SERVICE BULLETIN

N° 189-331

ATA 24 - NUMBER 1 VOLTAGE CONVERTER UNIT TIGHTENING TORQUE CALIBRATION

Figure 1

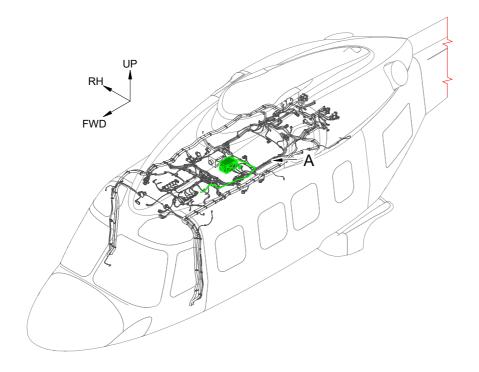
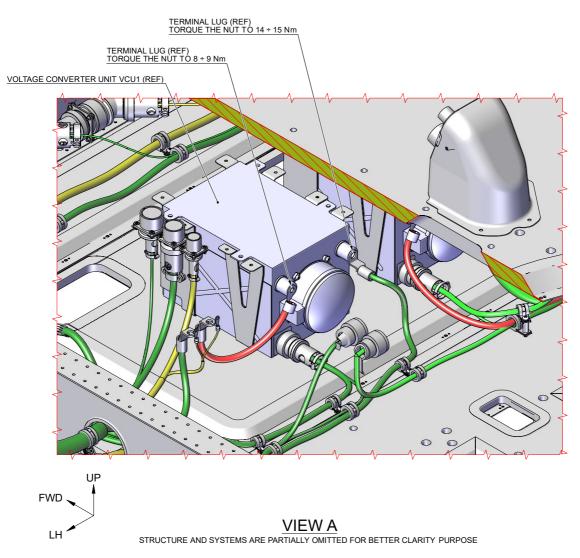
- 2.1 In accordance with applicable steps of AMP DM 89-A-24-31-01-00A-520A-A and with reference to Figure 1 View A, get access to VCU 1 and temporarily remove the indicated nuts from the two terminal lugs.

- 2.2 In accordance with applicable steps of AMP DM 89-A-24-31-01-00A-720A-A and with reference to Figure 1 View A, reinstall the previously removed nuts on the terminal lugs and tighten them to the correct torque value.
